SUBJECT: Request for Concurrence on the Explanation of Significant Differences for the Remedial Action at the Johns-Manville Superfund Site, Waukegan, Illinois

EXPLANATION OF SIGNIFICANT DIFFERENCES
for the
JOHNS-MANVILLE SITE
WAUKEGAN, ILLINOIS

figure 1.2
REMEDIED AREAS
MANVILLE DISPOSAL AREA
Waukegan, Illinois

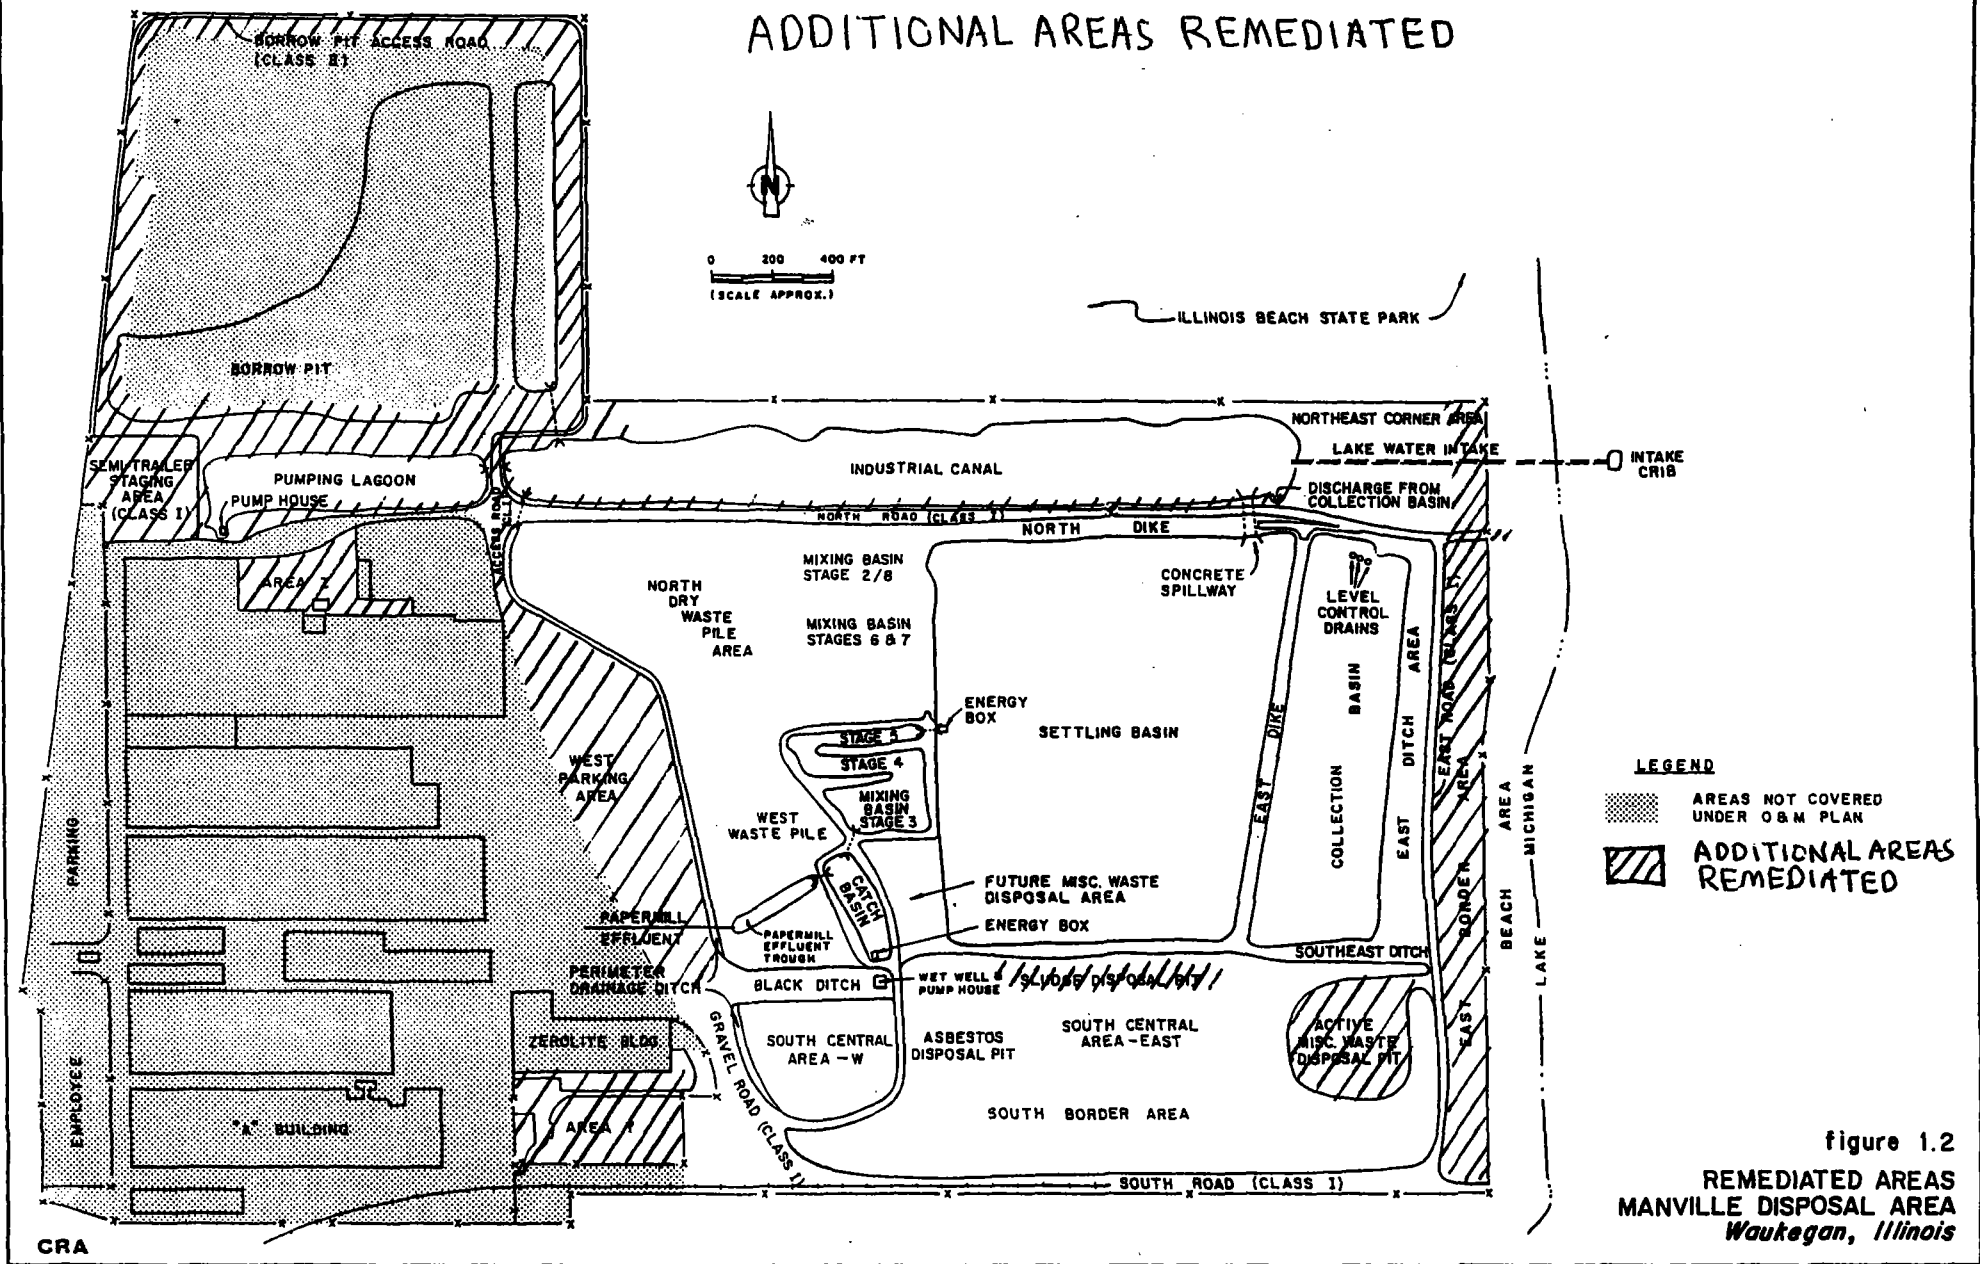
There were additional areas of the Site, not specified in the ROD, that were later identified as being contaminated with asbestos and, subsequently, were remediated. The first area was that surrounding the Industrial Canal, the Pumping Lagoon, and Eastern Site boundary. After trees near these areas were cleared during initial construction, waste products and materials resembling the sludge from the wastewater treatment system became visible. Representative samples collected in these areas in February 1990, revealed asbestos-containing material (ACM) located at or near the ground surface. Additional on-site sampling revealed that ACM was located at the ground surface of three additional areas--the borrow pit roadway, the boat storage area, and the non-functioning railway corridor. Manville submitted three additional work plans (the Second Work Plan Supplement, Second Work Plan Supplement-Amendment A and Third Work Plan Supplement) to address these additional areas of contamination. These additional work plans each contained a schedule for completion of remedial activities and were reviewed and approved by U.S. EPA and the Illinois Environmental Protection Agency (IEPA). Final remedial construction was completed on August 21, 1991.

The basis for remediating these additional areas was the same as that for remediating the areas originally designated in the ROD--to manage the risk to human health, safety, and the environment from friable asbestos. ACM was located at the ground surface and was, therefore, releasable to the air. All remediation of the additional areas was done consistent with the ROD - dry waste areas were covered with 24 inches of clean soil cover, with vegetation; areas at the edge of settling ponds/waterways were provided with one layer of nominal 12 inch thick riprap; and roadways were remediated consistent with the U.S. EPA-approved amended treatment requirements outlined below.
